SERVICE NOTES

B&W MODEL 5100 TRANSMITTER

MODIFICATION TO REDUCE BACKWAVE

INSTRUCTIONS FOR ADAPTING THE B&W MODEL 5100 TRANSMITTER
FOR USE WITH THE B&W MODEL 51SB SINGLE SIDEBAND GENERATOR

PARTIAL WIRING DIAGRAM
BUFFER-XTAL OSC.

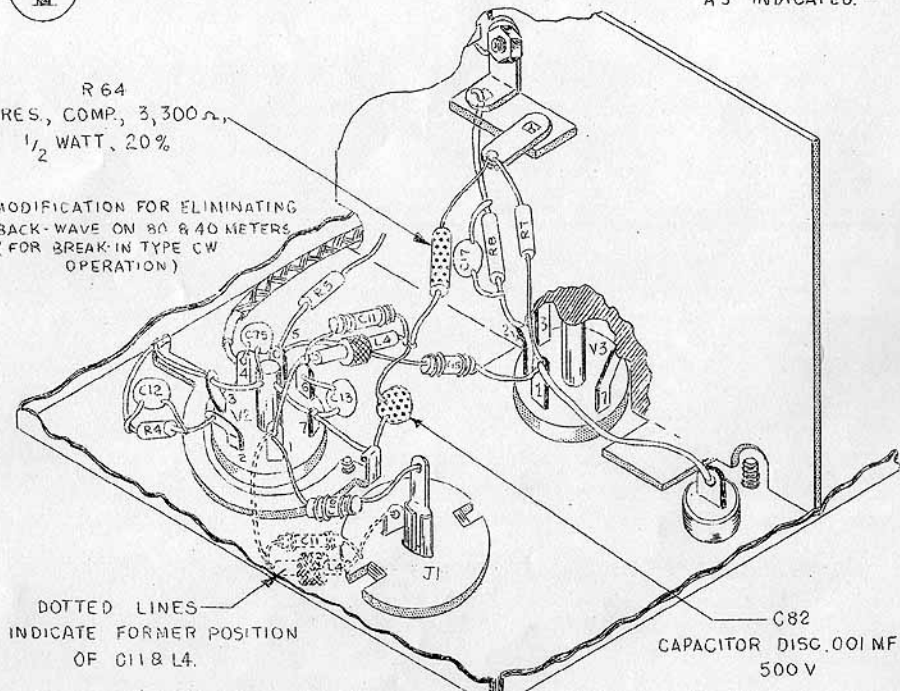
R64 & C82 TO BE ADDED
CHANGE POSITION OF C11 & L4
AS INDICATED.

MODIFICATION FOR ELIMINATING
BACK-WAVE ON 80 & 40 METERS
(FOR BREAK-IN TYPE CW
OPERATION)

1. Remove the "Buffer-Xtal Osc." Unit from the Transmitter.
2. Remove bottom shield from the unit by removing the six screws on the sides.
3. Referring to the accompanying drawing, disconnect the parallel combination of L4 and C11 from the ground lug of J1, and connect and solder to junction of R64 and C82 as shown.
4. Connect and solder other end of C82 to ground lug as shown.
5. Connect and solder R64 and R7 as shown.

BIAS MODIFICATION

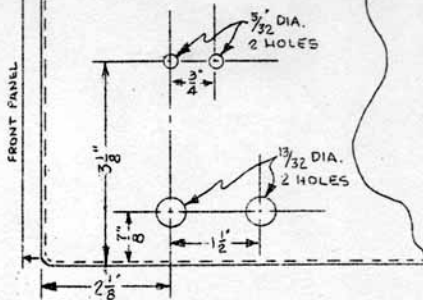
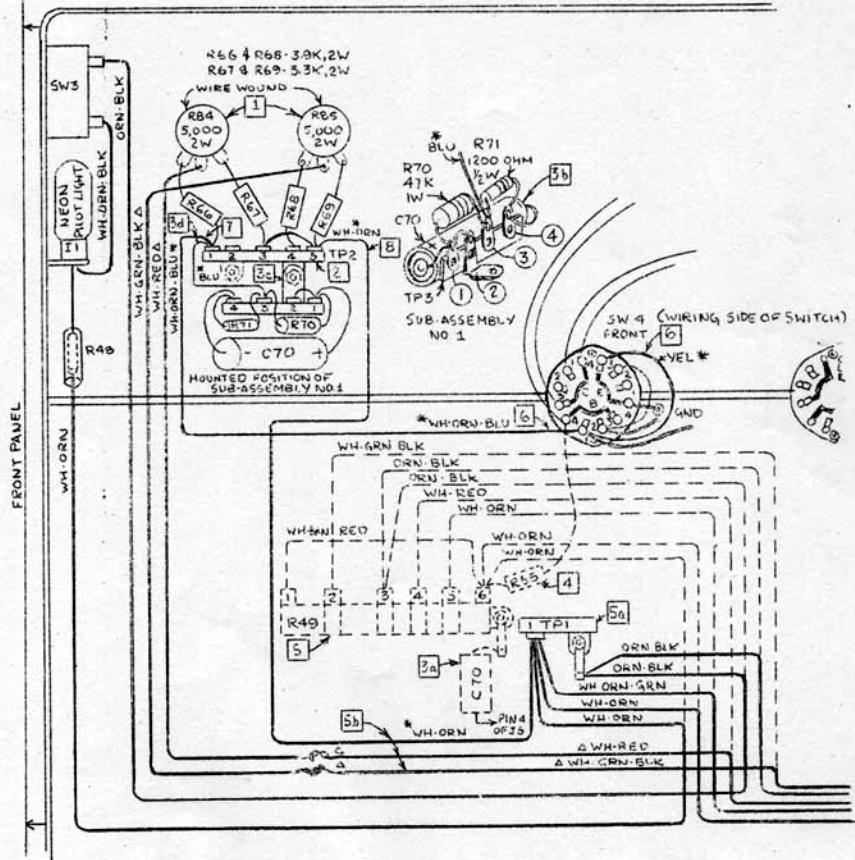
1. X - INDICATES 4 ADDITIONAL WIRES (WH-OR, WH-ORN, BLU, BLU #VEL)
2. A - INDICATES EXISTING WIRES WHICH ARE TO BE SPLICED FOR ADDITIONAL LENGTH (WH-RED & WH-GRN-BLK)
3. DASHED LINES (---) INDICATE FORMER ARRANGEMENT, SOLID LINES & HEAVY CONNECTIONS (—) SHOW MODIFICATION.

1. Place two 5,000 ohm pots. (R84 & R85) in 13/32" dia. holes, and secure in place.
2. Place five terminal tie point (TP2) in 5/32" dia. holes. Tighten the nut nearest the front panel, leave other nut loose for mounting of sub assembly #1. At this point connect and solder resistors R66, R67, R68, and R69 as shown, also connect jumper wire between 3 and 5 of TP2.

3. Prepare Sub Assembly #1
 - a. Carefully remove C70 from terminal 4, of J5 (12 pin Jones Conn.) and ground lug on mounting screws (nearest back of chassis) of R49.

- b. Prepare Sub-Assembly #1 by using 4 terminal tie point (TP3) and two resistors (R71 & R70), and C70 (removed in (a)). Connect these items as shown by attached drawing. (Observe polarity on C70). Also connect jumper between terminals 1 and 2 of TP3, and attach 2" Blue lead to Terminal 3 of TP3.

- c. After completing sub-assembly #1 attach the entire sub-assembly to TP2 by means of mounting tab on TP3. Tighten nut to secure position.
 - d. At this time connect other end of 2" Blue lead to Terminal 1 of TP2.

4. Delete resistor (R55) which is connected from SW4 Section B Terminal 4, and terminal 6 of R49 (end towards back of chassis).
5. Delete R49 by unsoldering all wires, and removing mounting screws.

- a. The one terminal tie point (TP1) is then mounted in mounting hole of R49 (one nearest back of chassis). Place solder lug over mounting screw before securing into place.

- b. Connect wires removed from R49 to TP1 as shown by attached dwg. Two leads (Wh-Red & Wh-Grn-Blk) are to have additional lengths added. (Be sure to tape wires securely after splicing). One 12" (Wh-Orn) lead is added at this point.

6. Remove switch SW4 from its bracket, and solder jumper wire (yellow) between Contact 1 of Section B and Contact 3 of Section E. Also solder a 12" (Wh-Orn-Blu) lead to contact 1 of Section B. Place switch back in its brackets and secure.

7. Connect other end of (Wh-Orn-Blu) lead used in step 6 to terminal 1 of TP2.
8. Connect other end of (Wh-Orn) lead used in step 5 (b) to terminal 5 of TP2.
9. After you have checked with the drawing to see that all connections are correctly made, dress wires into cable.
10. Replace Multiplier Unit and all Tubes.
11. Make sure that the bias potentiometers are in the extreme counter-clockwise (maximum bias) position before application of plate voltage.

CIRCUIT CHANGES

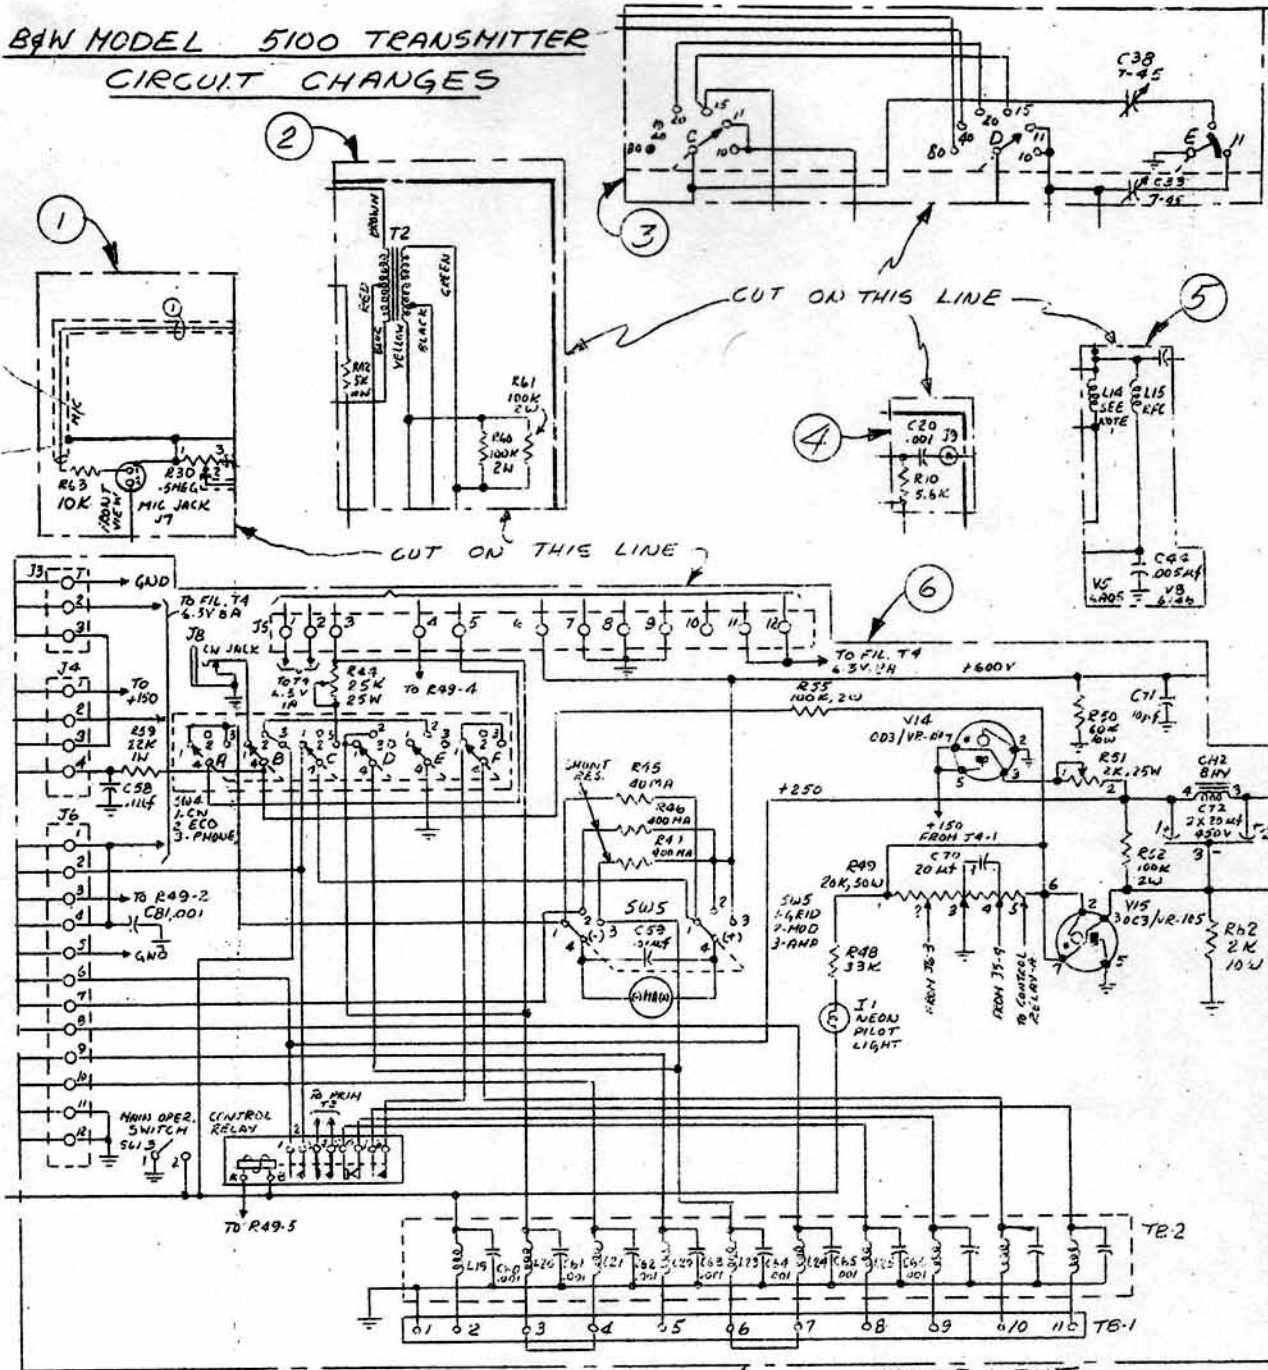
NOTE:
 THESE CORRECTED CIRCUITS HAVE BEEN DRAWN TO SCALE, CUT OUT AS SHOWN AND PASTE ON INSTRUCTION MANUAL SCHEMATIC IN PROPER PLACES AS INDICATED BY CIRCLED NUMBERS ①②③④⑤⑥.

- ① - MODULATOR (CIRCUIT OUTSIDE OF HEAVY LINE)
- ② - MODULATOR (UPPER RIGHT HAND CORNER)
- ③ - MULTIPLIER - FINAL AMP. (TOP, C.D.B.E OF SW)
- ④ - BUFFER - XTAL OSCILLATOR (UPPER RIGHT)
- ⑤ - MULTIPLIER - FINAL AMP. (LOWER RIGHT, ABOVE FIL)
- ⑥ - POWER SUPPLY

CIRCUIT MODIFICATIONS FOR ADAPTING E&W MODEL 5100 TRANSMITTER FOR USE WITH E&W MODEL 5158 SINGLE SIDEBAND GENERATOR (SEE INSTRUCTION SHEET FOR PROCEDURE)

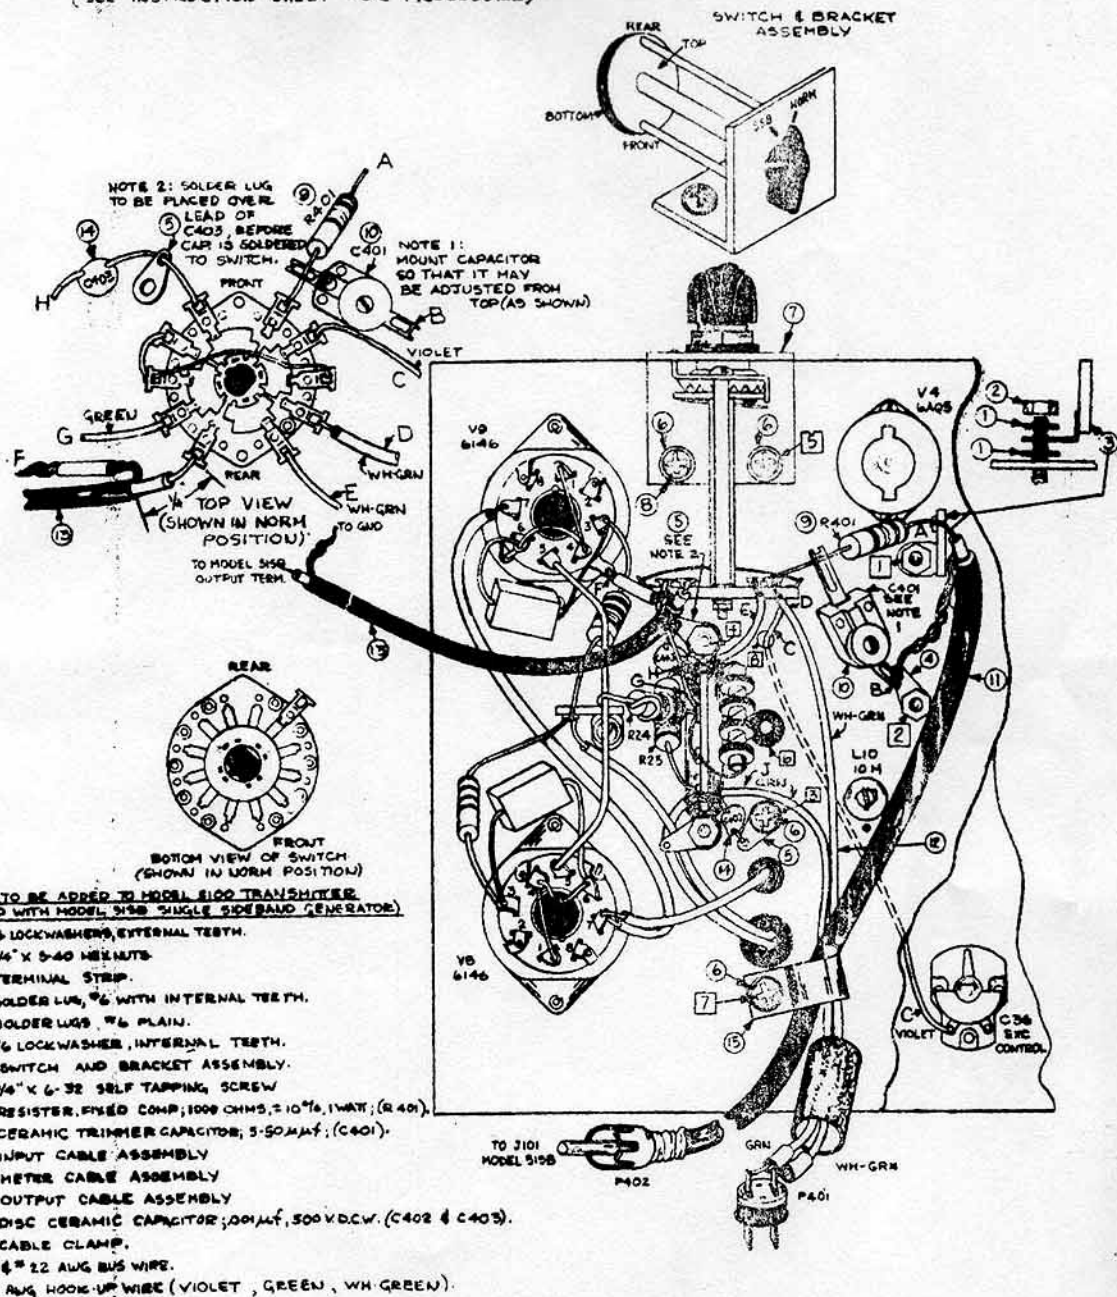
ITEMS TO BE ADDED TO MODEL 5100 TRANSMITTER
(SUPPLIED WITH MODEL 5158 SINGLE SIDEBAND GENERATOR)

4. Delete spaghetti covered wire connecting excitation control C36 to R24. (This is the wire passing through grommet [6], and is deleted in drawing.)
5. Remove switch nut and washers, [1], and mount terminal strip, item [3], with two shakeproof washers, item [1], and $\frac{1}{2}$ x 5-40 nut, item [2], while holding switch bolt from inside of chassis to prevent bolt from turning.

6. Remove switch nut and washers, [2], and mount lockwasher type solder lug, item [4], with the $\frac{1}{2}$ x 5-40 nut, item [2], while holding switch bolt from inside of chassis to prevent bolt from turning.

7. Fasten solder lug and lockwasher, items [5] and [6], under screw [3].
8. Solder jumper wires between switch contacts as shown on detail of switch wafer.

9. Remove top screw, [5], from chassis; attach switch and bracket assembly, item [7], to chassis by means of screw, [5], and lockwasher, item [6].
10. Drill hole ($7/64$ " dia. or #35 drill) through chassis, using mounting hole in switch bracket as template. Before drilling hole, make sure that top edge of bracket is parallel to top edge of chassis.

11. Add screw, item [8], and lockwasher, item [6], to secure switch bracket to chassis.
12. Solder capacitor, C403, item [14] to switch contact, solder lug, and terminal strip as shown in note 2 and drawing.

13. Fasten solder lug, item [5], under nut [4].

14. Solder green lead "G" between switch contact and terminal strip as shown. (Make lead short as possible.)
15. Solder White-Green lead, "E", between switch contact and terminal strip as shown. (Make lead short as possible.)

16. Solder shielded input cable assembly, item ⑪, to terminal strip, item ③, and solder lug, item ④, as shown.
17. Solder R401 and C401, items ⑨ and ⑩, between switch contact, terminal strip, items ③, and solder lug, item ④, as shown.

18. Remove screw ⑧ from chassis (shown deleted on drawing), and solder violet lead, "C", to switch contact and excitation control C36, passing wire through hole left by removing screw ⑧. (DO NOT pass this wire through the grommet hole ⑥.)

19. Solder meter cable assembly, item ⑫, to switch (White-Green) and terminal strip (Green) as shown.
20. Solder capacitor, C402, item ⑭, between terminal strip and solder lug, item ⑤, as shown.

21. Solder output cable, item ⑬, to switch and ground lug of V9 as shown.
22. Fasten cable clamp, item ⑮, over cables, item ⑪ and ⑫, by means of screw ⑦ and lockwasher, item ⑥, as shown.
